U. Mass. T. 101

Solid angles for shipment of propane - 70 x 2/6/62

Conclusions: a. I checked Muller's calc - see 2/6/62 letter

REFER TO SKETCH OF 22 UNIT ARRAY IN TRUCK

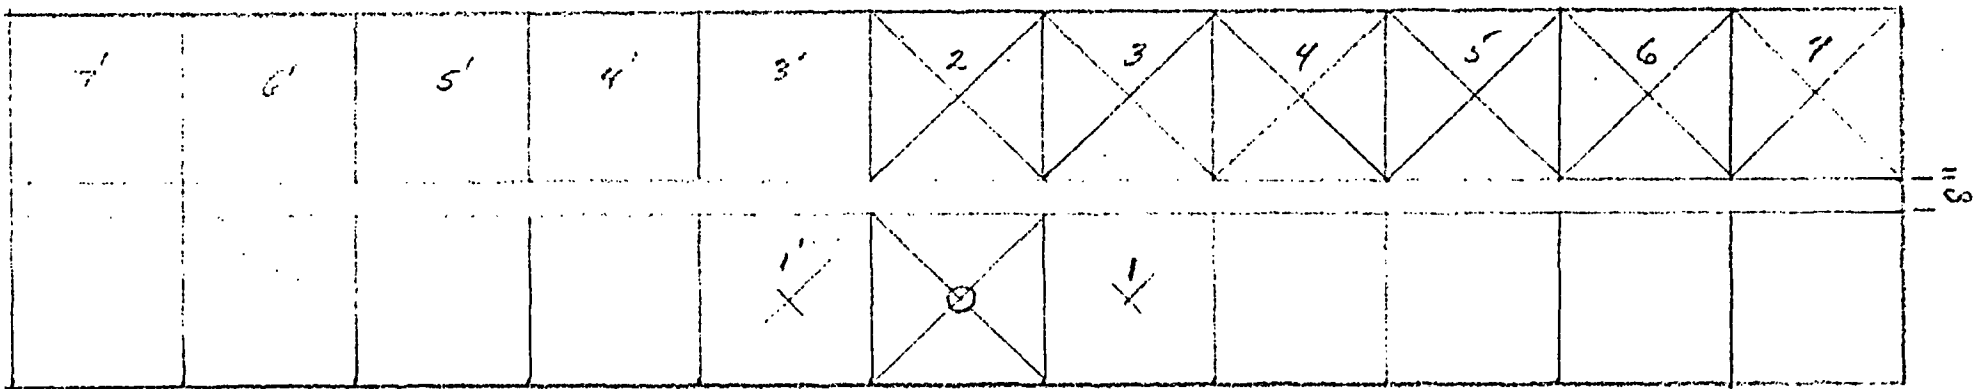
* MALLINCKRODT SOMEWHAT HIGHER IN
COMPUTED SOLID ANGLE BECAUSE:

(1) Method of K-1309 is non-conservative by as 5%
in this range (Values of \bar{v} too low in comp. with $\frac{2d \sin \theta}{r}$)

no (2) I used 3' 7" as side dimension of package
(in TIV-1011) whereas Mall used 3' 6" used 6"

(3) I assumed cages along sides of truck (see
sketch) with 8" blocks separating rows. Makes
 \bar{v} to 2, 3, 4, 5, 6 and 7 a little lower. To drums 1 and
1' I reversed to no cage sep., giving $\bar{v} = .916$

b. My calc are in general agreement with Muller's, but somewhat low. See reasons given on p. 2

c. It is recommended approval of 2-6-62 3/7/62.
